City of Richmond

Report to Committee Planning and Development Department

File: RZ 13-643655

Re: Application by Yin P. Mui for Rezoning at 10491 No. 1 Road from Single Detached (RS1/E) to Coach Houses (RCH1)

PROPOSED SITE PLAN

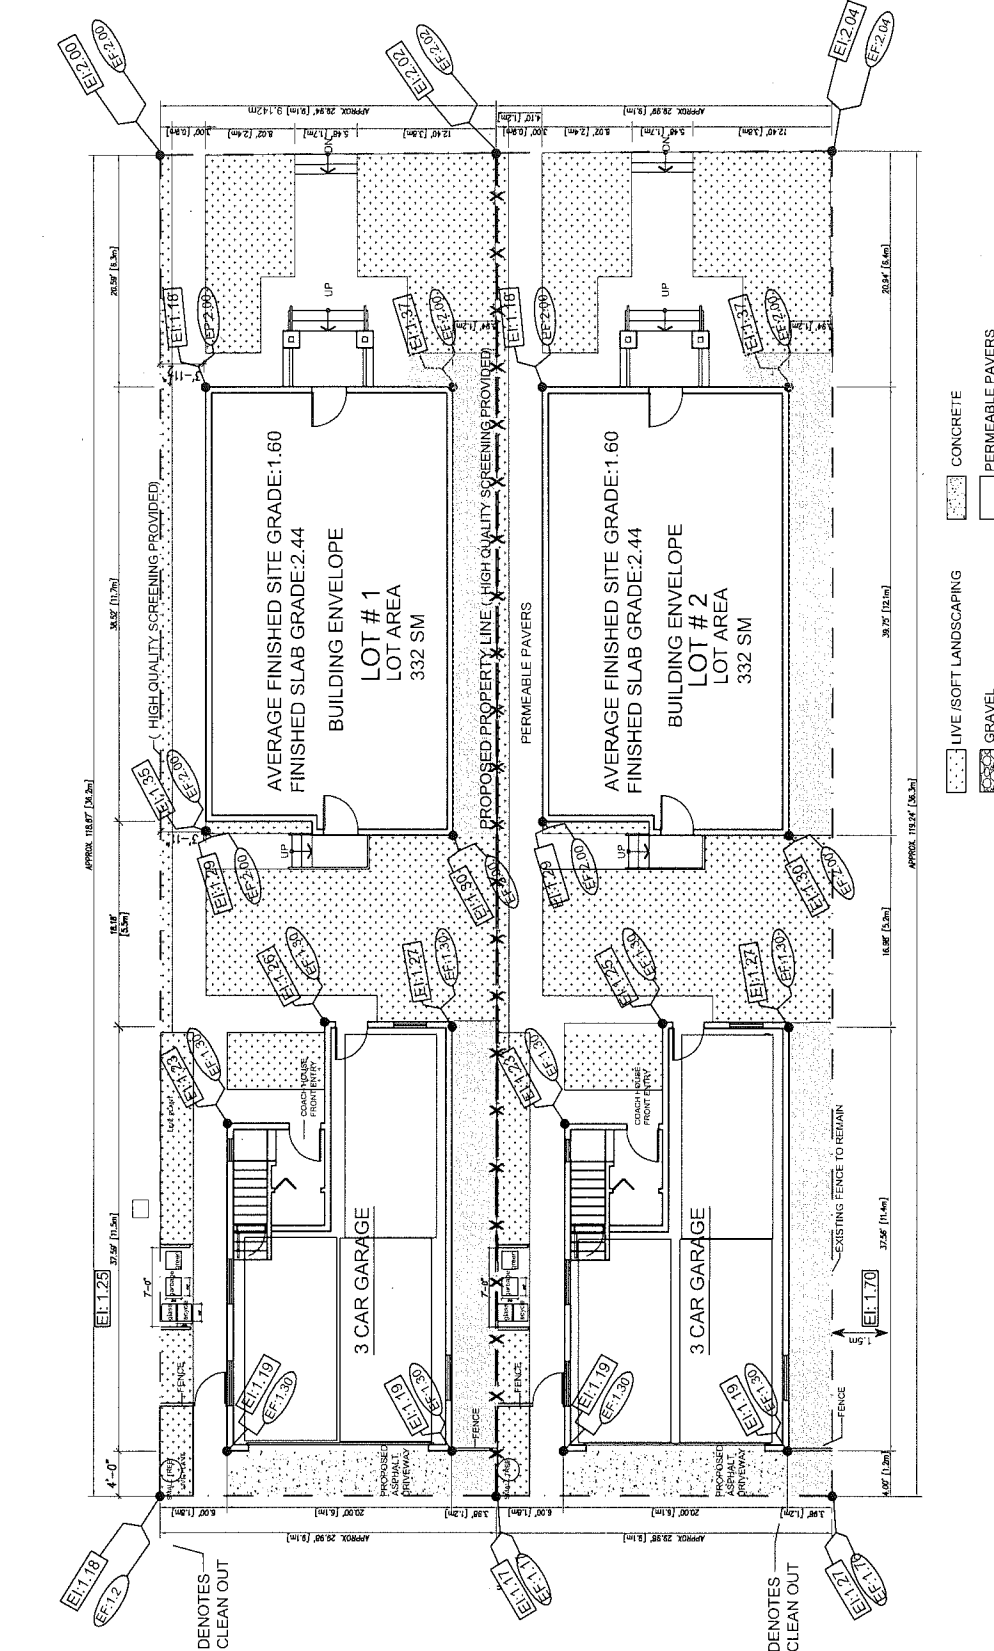
Prior to final adoption of the Rezoning Bylaw, refinements must be made to the conceptual plans include in Attachment 5 with respect to: a) enhancing the entry to the coach house on each lot; b) clarifying the proposed fencing in the rear yard; and c) providing more variety in the proposed exterior cladding materials and colour scheme. Furthermore, the applicant must register restrictive covenants on Title of the lot to ensure that:

1. Submission of revised conceptual plans for the coach houses as it relates to: a) enhancing the entry to the coach house on each lot; b) clarifying the proposed fencing in the rear yard; and c) providing more variety in the proposed exterior cladding materials and colour scheme.

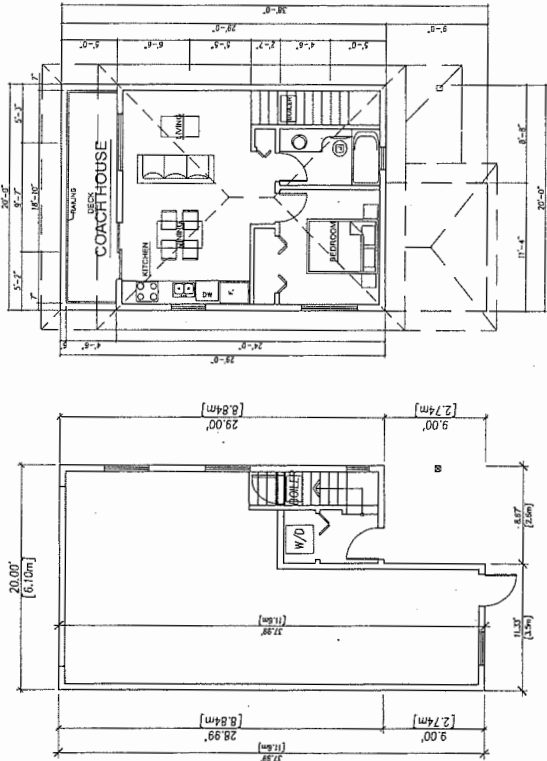
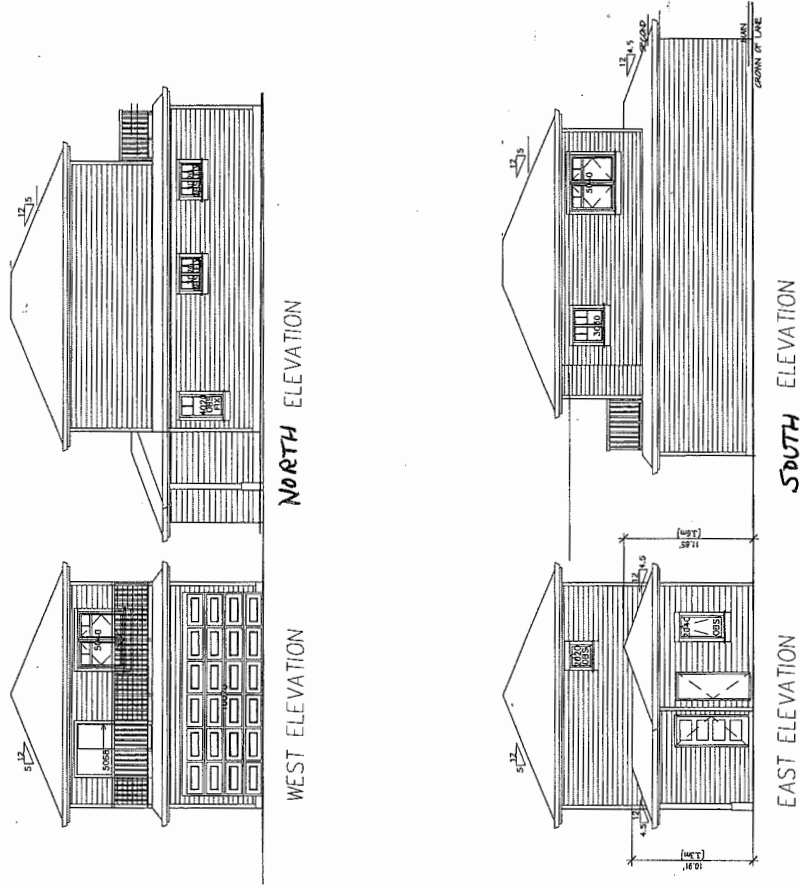
The proposed architectural elevation plans show a hipped roof, along with a sloping skirt roof on all elevations to define each storey of the coach house. The proposed elevation facing the lane provides visual interest by incorporating a raised panel garage door, balcony and railing, and window openings. The exterior materials proposed for the coach house on each lot consist of horizontal siding.

Proposed Tree Retention Plan

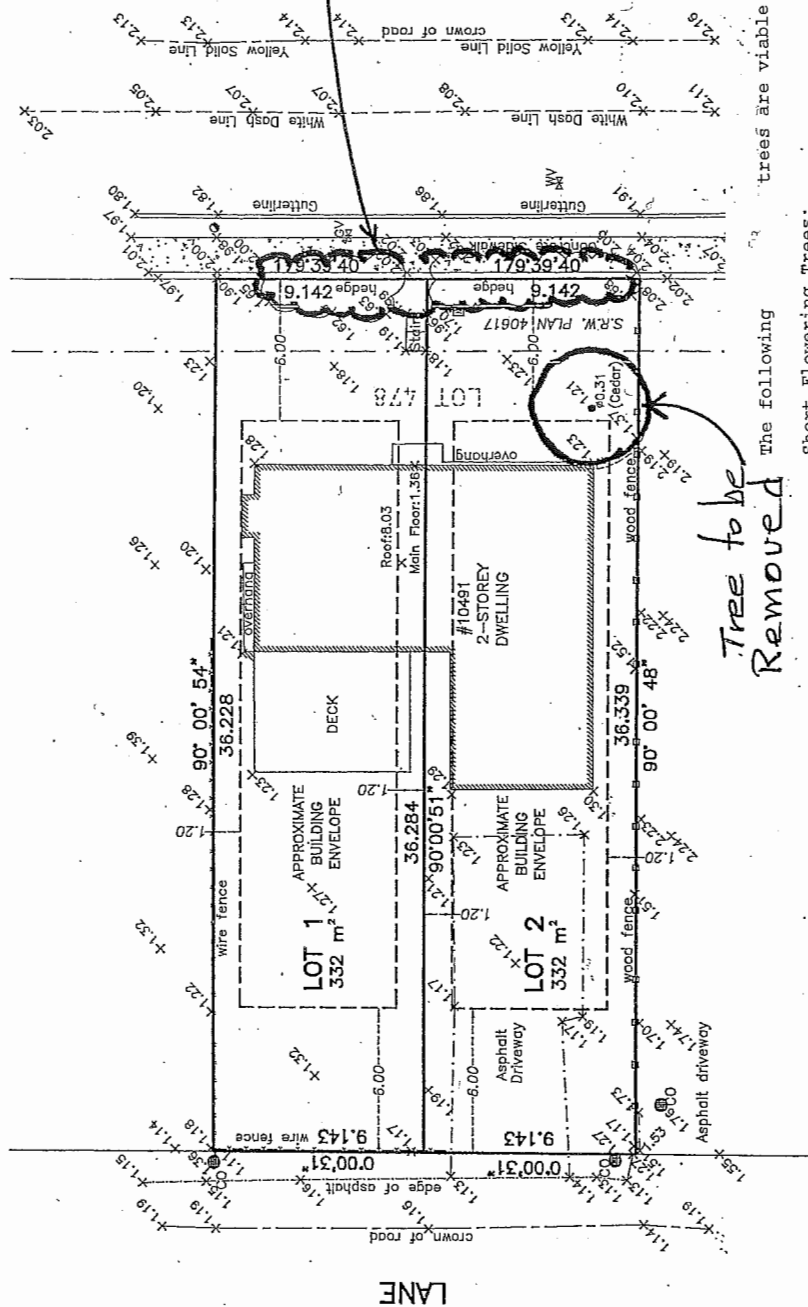
The City's Tree Preservation Coordinator has reviewed the Arborist's Report, conducted visual tree assessment, and indicates that Tree # 1 is not a good candidate for retention, as it has been historically topped and will be located too close to the dwelling within the front yard of the proposed south lot to be successfully retained. In addition, proposed lot grading to comply with the minimum flood construction level would further limit the viability of this tree. The City's Tree Preservation Coordinator recommends that the tree be removed and replaced at a ratio of 2:1.

To compensate for the removal of Tree # 1, the applicant is required to plant and maintain two (2) replacement trees (minimum 8 cm deciduous caliper or 4 m high conifer) on the proposed lots. In addition, the landscaping guidelines of the Arterial Road Policy require that one (1) additional tree be planted and maintained in the front yard of each lot proposed (minimum 6 cm deciduous caliper or 3.5 m high conifer).
